# **WATERLOO METRO QUARTER CENTRAL PRECINCT**

## **SSD-10439 - RESPONSE TO SUBMISSIONS DESIGN STATEMENT**

**DPIE RFI - 13/04/2021**

Plan of typical floor plate

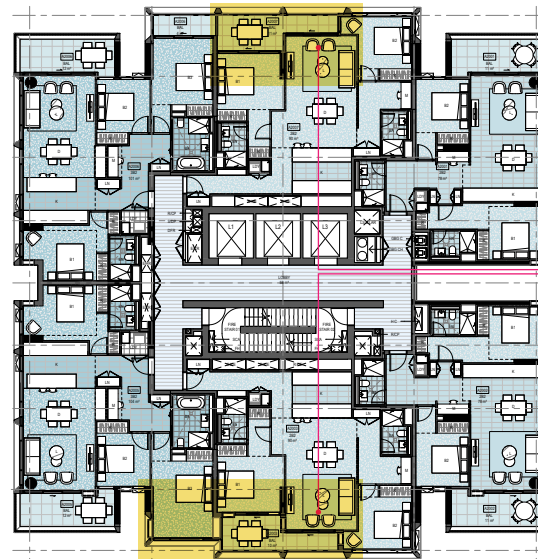
Living room glazing and balustrade shift east. Corner column reshape and relocation.

Living room glazing and balustrade shift west. Corner column reshape and relocation.

Living room facade shift east to allow north frontage for adjacent POS

Living room facade shift east and west.

### Proposed Design Changes to South East Apartment

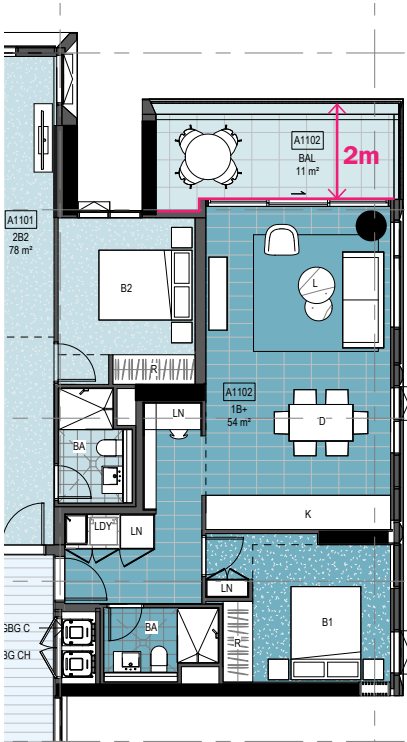
Glazing and balustrade to move east by 240mm to improve solar amenity of the living room while maintaining the depth required for POS.

Reshape and relocate south east column to be within the apartment to maximise glazing to the living room.

With the above design change, the solar amenity to the living room between level 3 and level 21 are improved by 10mins compared to the DA scheme. The living room window receives more than 1sqm of direct sunlight for 1 hour and 40 mins between 9:00am and 10:40am mid winter.

### DA Scheme

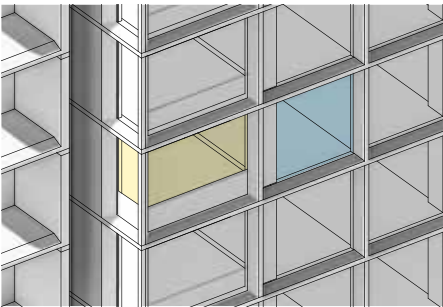
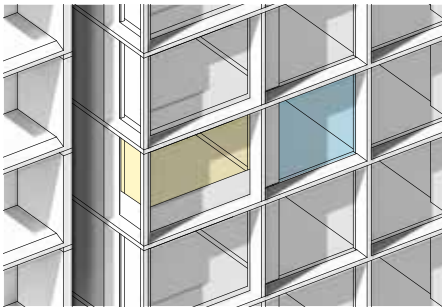
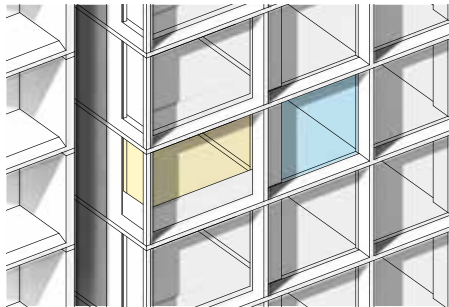
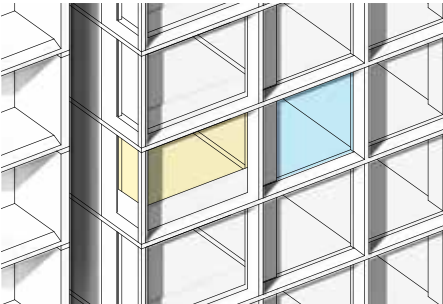
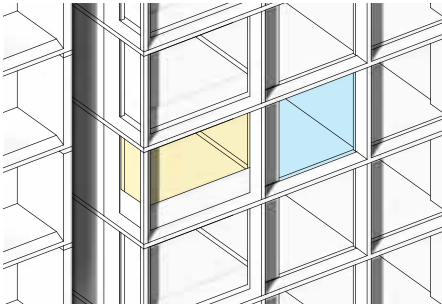
The living room of west facing 1 bedroom apartment complies with ADG solar access requirement while the POS of the apartment achieves 10mins of 1 sqm direct solar between 2:50pm and 3:00pm mid winter.

The opportunity was explored to improve solar access of the POS by shaping the western facade to achieve full compliance.

Diagrams below shows the solar amenity to the living room window of the DA scheme. The living room window receives more than 1 sqm of direct sunlight for 2 hours between 1:00pm and 3:00pm mid winter.

### Proposed Design Changes to West Apartment

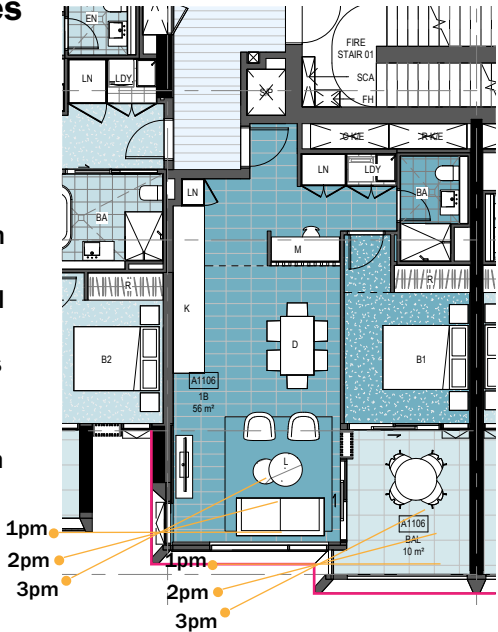
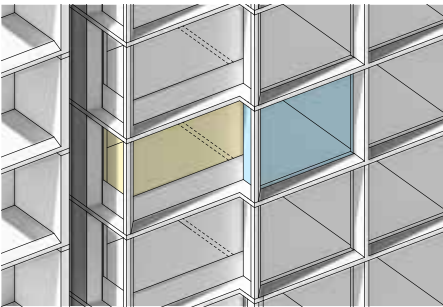
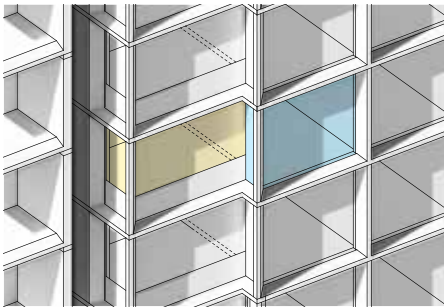
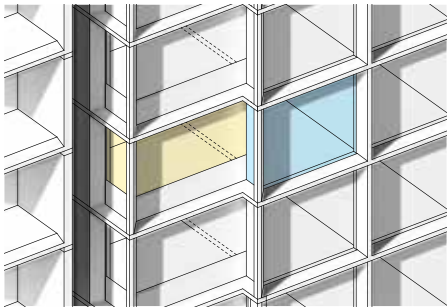
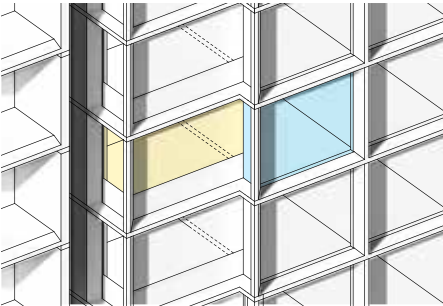
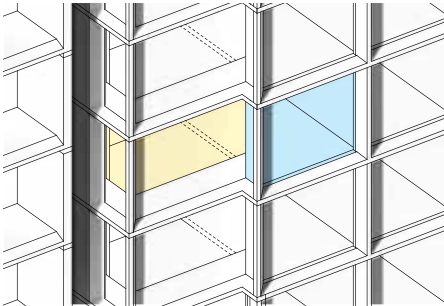
The west facade of the 1 bedroom apartment living room to shift east 700mm to provide north facing frontage to the adjacent POS.

With the above design change, both the living room and POS of the 1 bedroom apartments between level 6 and level 19 achieve 1 sqm of solar access for 1 hour and 50mins between 1:10pm and 3:00pm mid winter. The living room and POS recieve solar access for a minimum of 2 hours between 9:00am and 3:00pm but less than 1sqm for 10 mins.

### DA Scheme

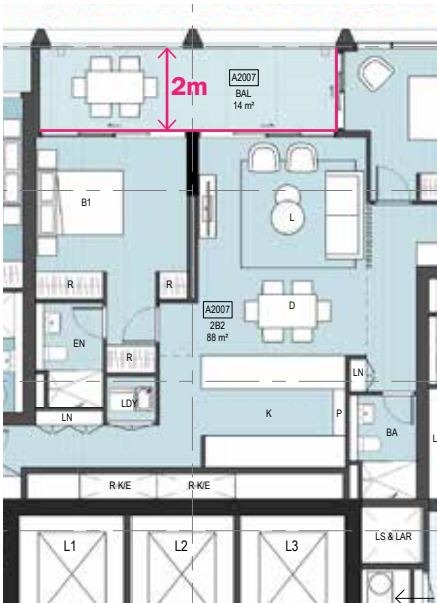
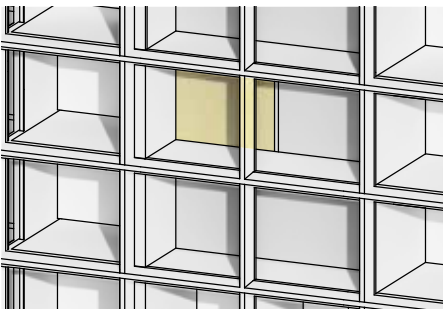
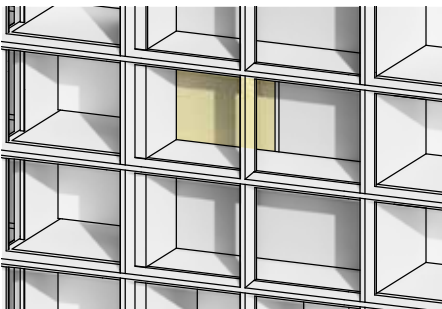
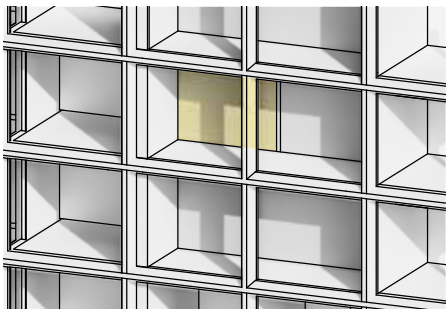
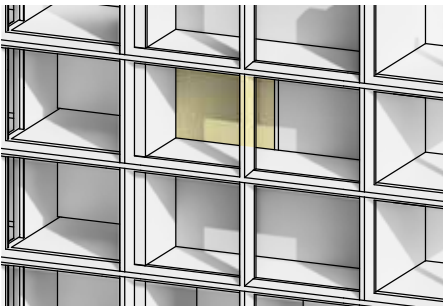
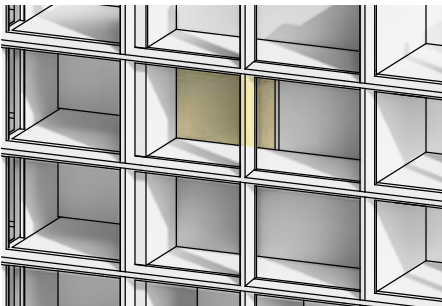
The POS of east facing captured 2 bedroom apartment on level 20 and 21 complies with ADG solar access requirement while the living room of the apartment achieves 1 hour and 20 mins of direct solar between 9:00am and 10:20am mid winter.

There is opportunity to shape the living room glazing to achieve full compliance.

Diagrams below shows the solar amenity to the living room window of the DA scheme. The living room window receives more than 1sqm of direct sunlight for 1 hour and 20 mins between 9:00am and 10:20am mid winter.

### Proposed Design Changes to East High Rise Apartment

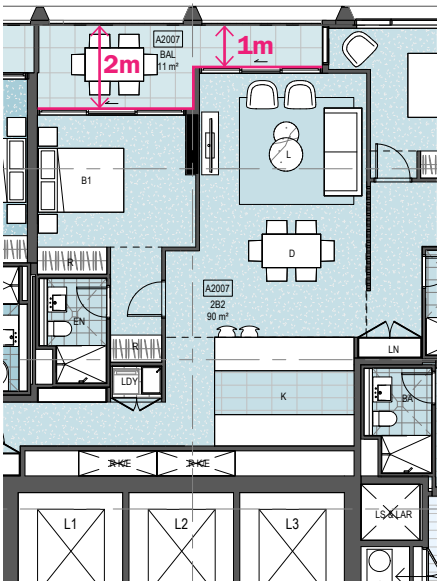
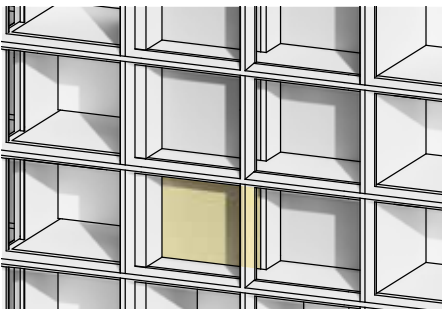
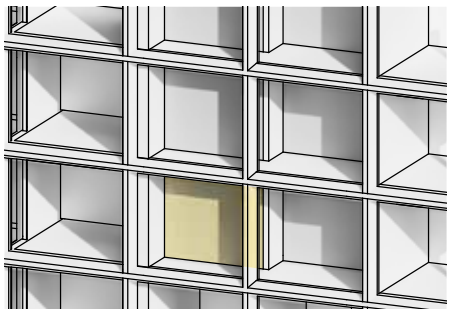
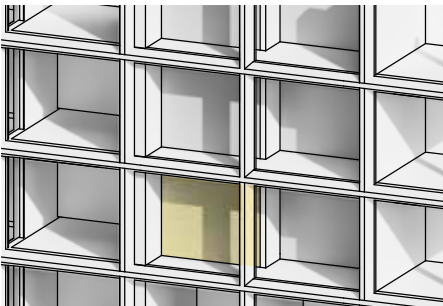
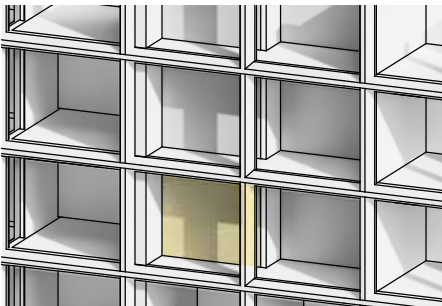
The living room glazing is shifted east by 1m while maintaining the minimum requirement for depth and size of the POS in accordance to ADG.

With the above design change, both the living room and POS of the captured 2 bedroom apartments on level 20 and 21 receive 1sqm of solar access for 2 hours between 9:00am and 11:00am mid winter.

### Proposed Design Changes to West High Rise Apartment

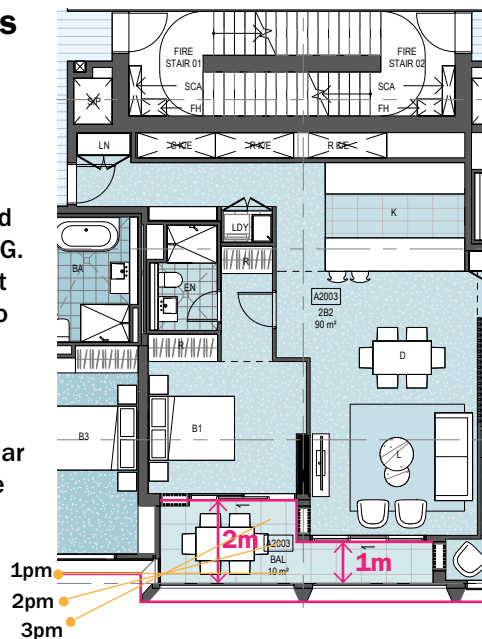
Opportunity to improve solar access to living room and POS by adopting the same change as the east high rise apartments.

The living room glazing is shifted east by 1m while maintaining the minimum requirement for depth and size of the POS in accordance to ADG. The bedroom of adjacent apartment to shift east 700mm to allow POS to have north facing frontage.

With the above design change, the POS on level 20 and 21 receives 1 hour and 50mins of 1sqm direct solar between 1:10pm and 3:00pm while the living rooms receive 50 mins of direct solar between 2:10pm and 3:00pm.
